RE: PETITION FOR SPECIAL EXCEPTION : BEFORE THE ZONING COMMISSIONER
PETITION FOR VARIANCE
N/S of Bellona Ave., 74.39' W of: OF BALTIMORE COUNTY
Lutherville Rd. (1312 Bellona Ave.), 8th District

SUBJECT: Zoning Petition No. 87-244-XA

PROJECT NAME: 1312 Bellona Avenue

PETITIONER:
PLAT TO ACCOMPANY A PETITION FOR A SPECIAL EXCEPTION FOR A CLASS 'B' OFFICE BUILDING AND VARIANCE
1312 BELLOVA AVENUE
BALTIMORE COUNTY

PROPOSED OFFICE BUILDING
1312 BELLONA AVENUE
2 OCTOBER 1986

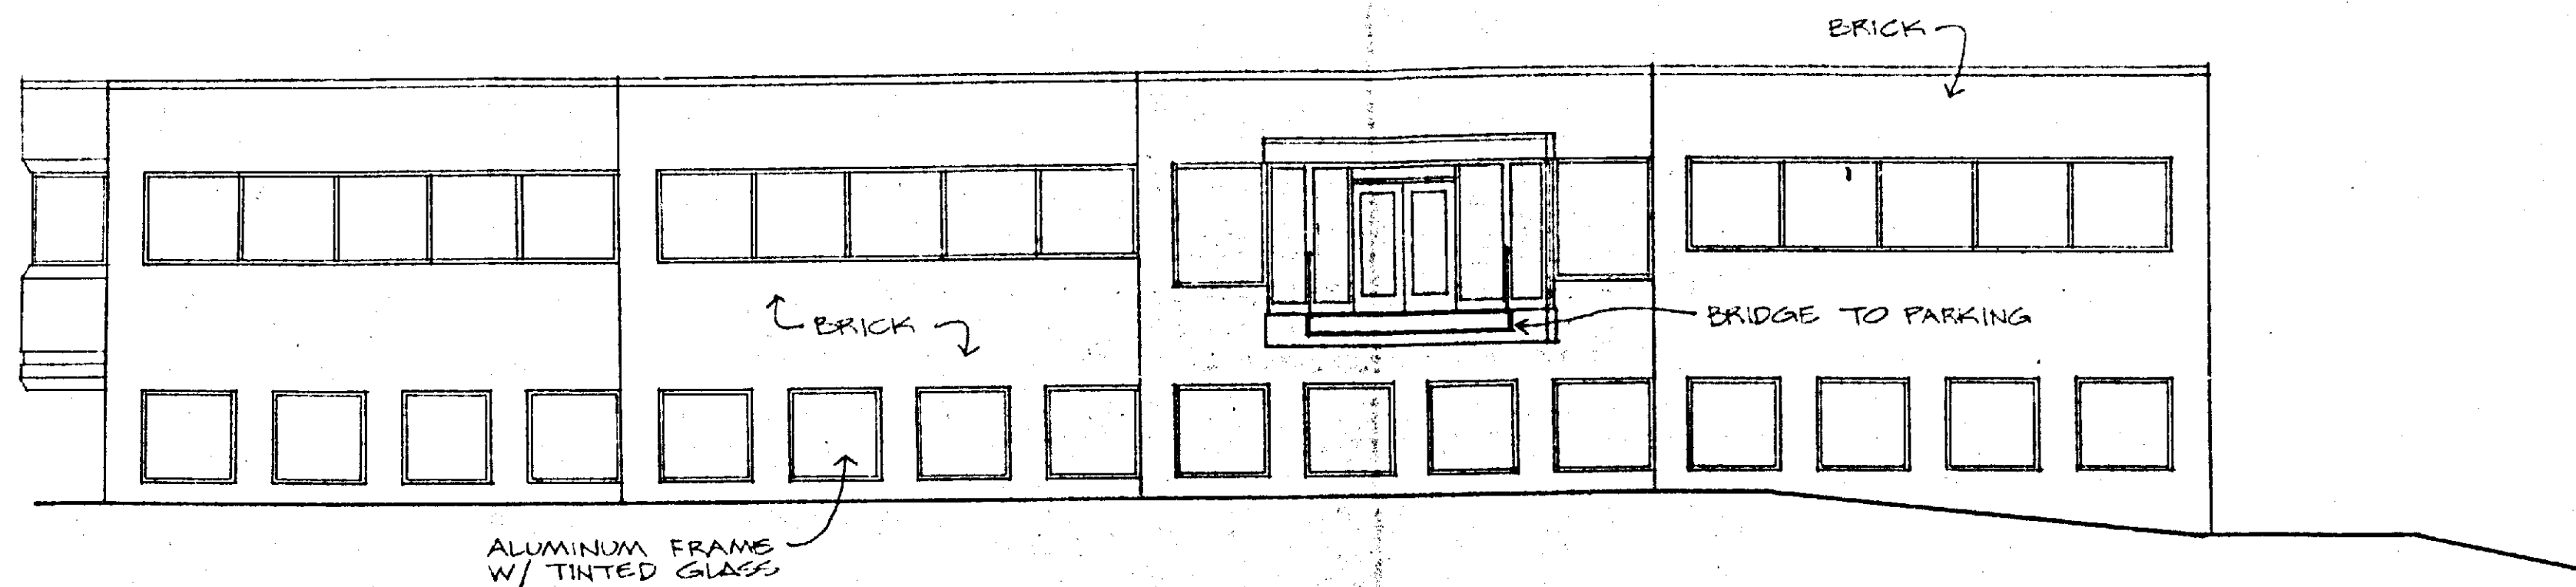
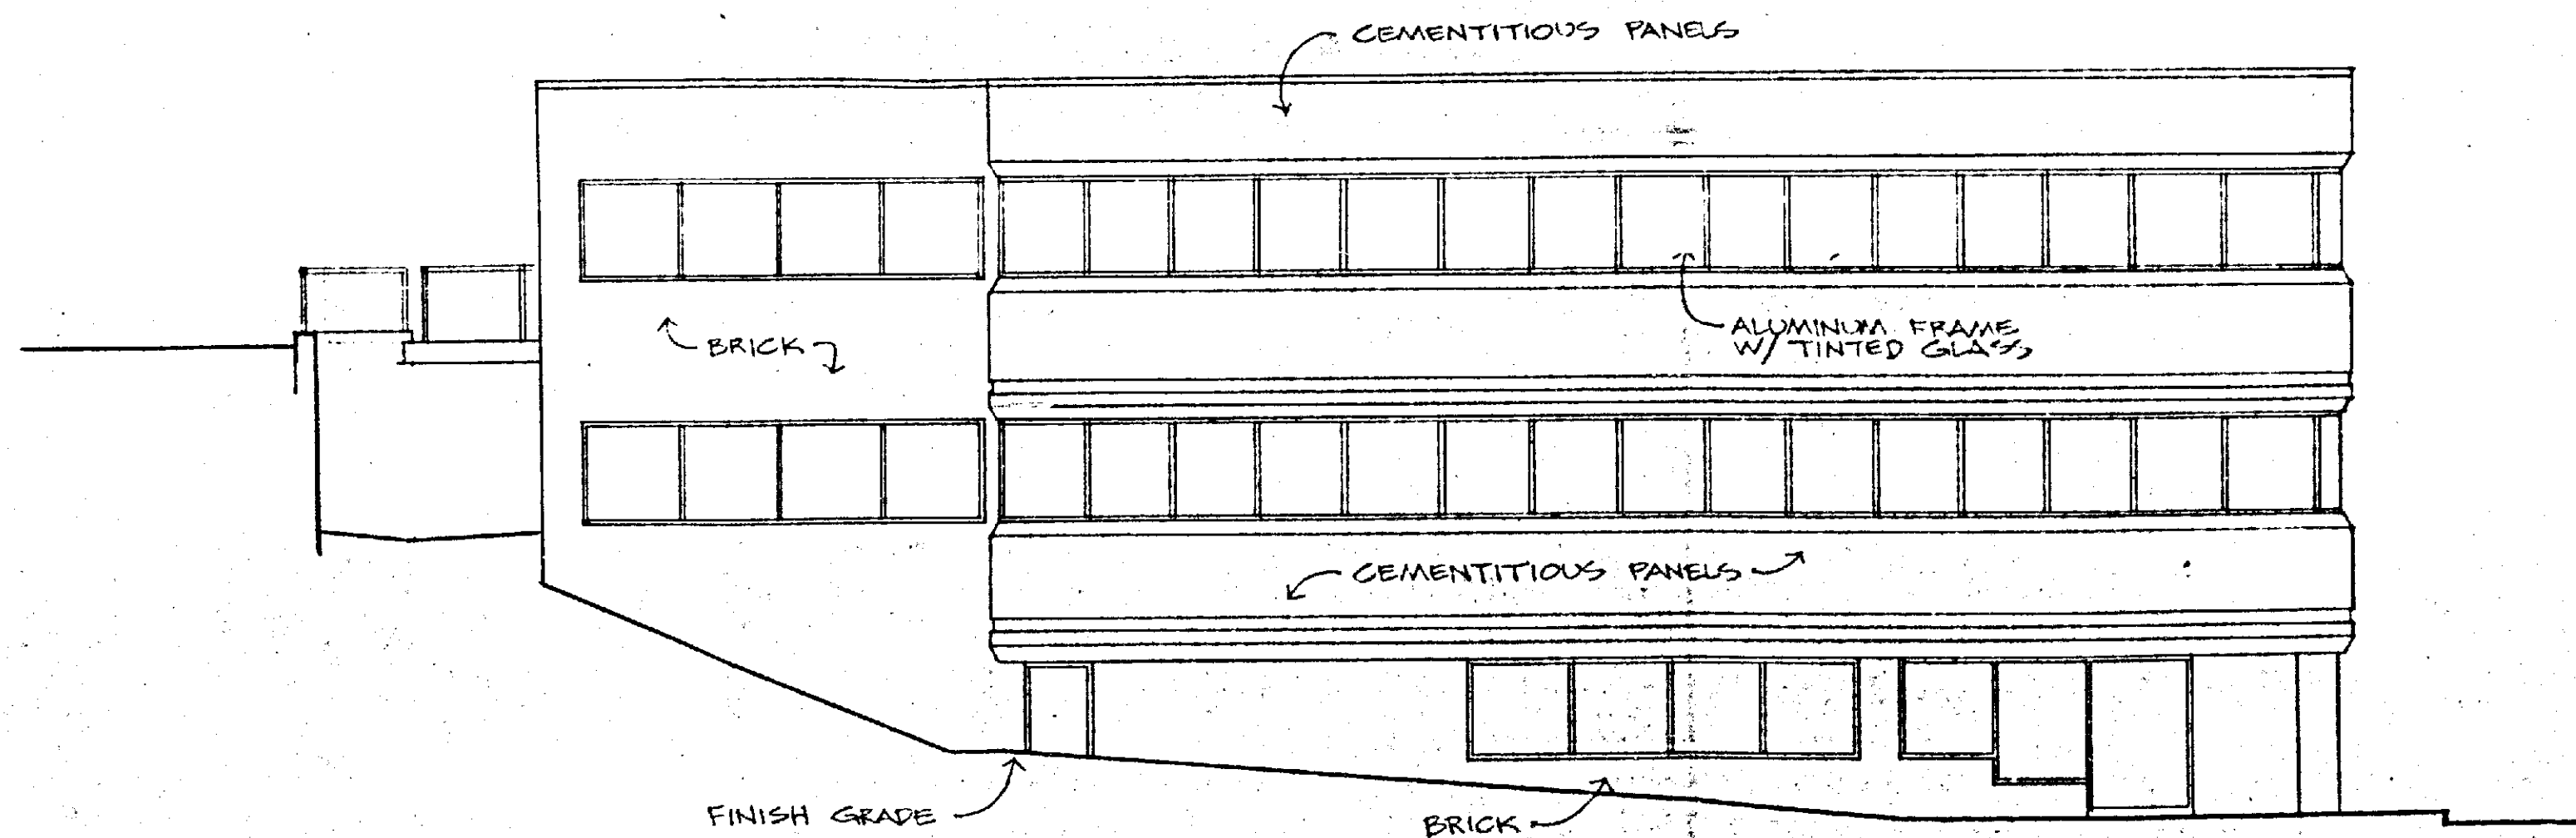
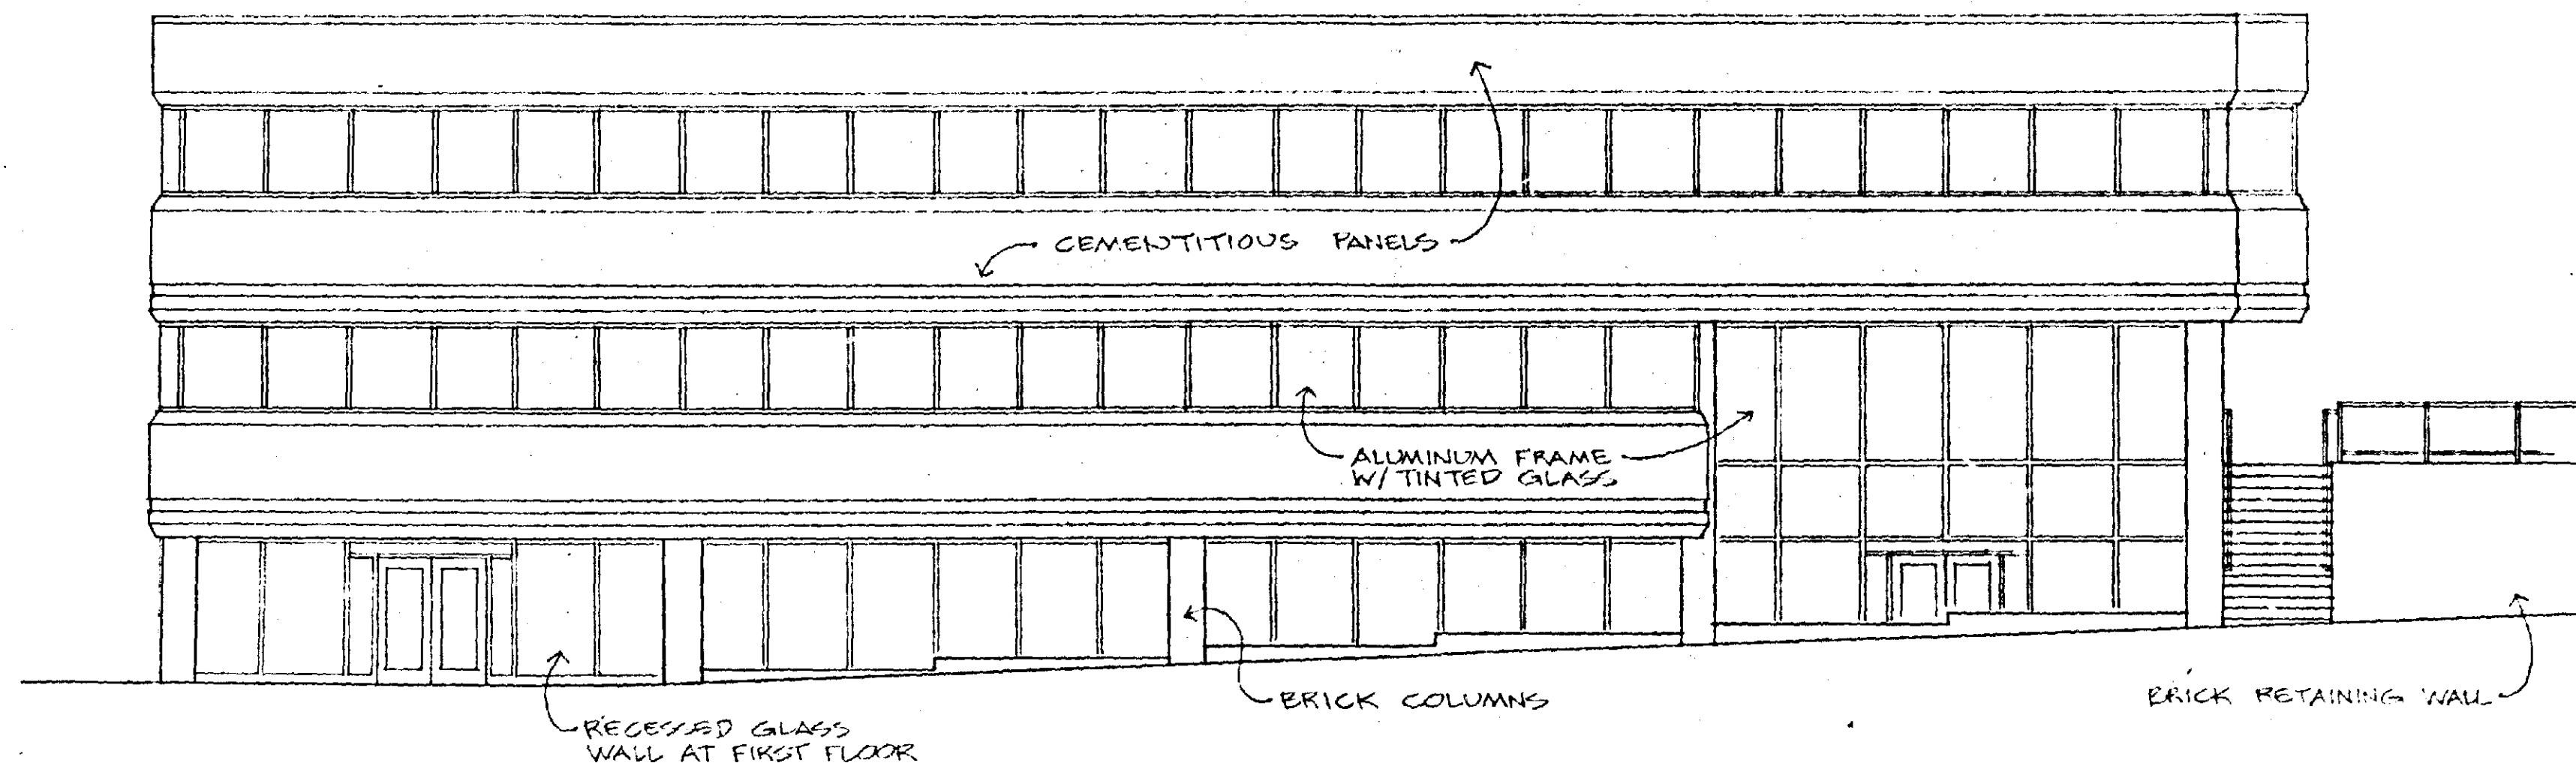
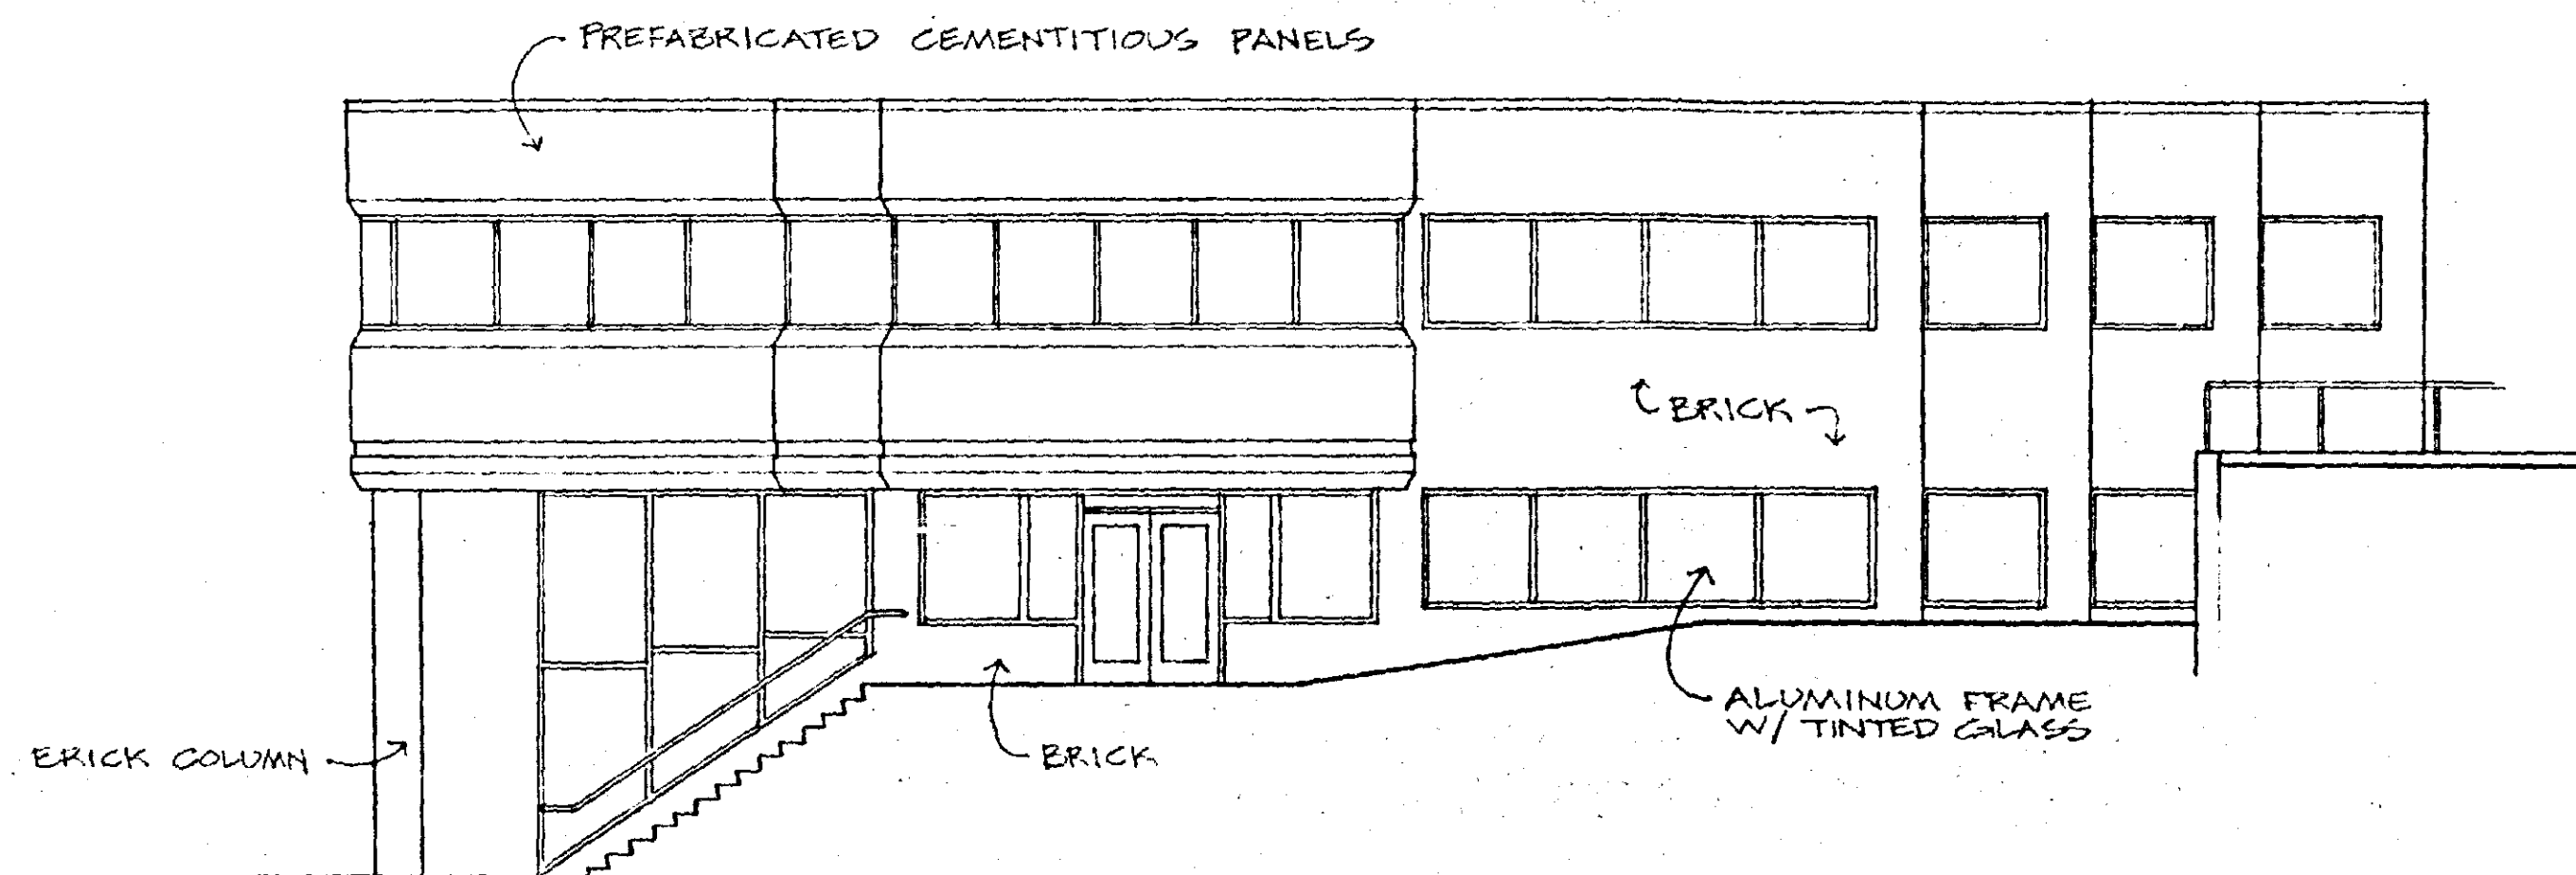
4) Indicate the natural grade on the height dimension on the elevation drawings. Also, exterior materials should be indicated.
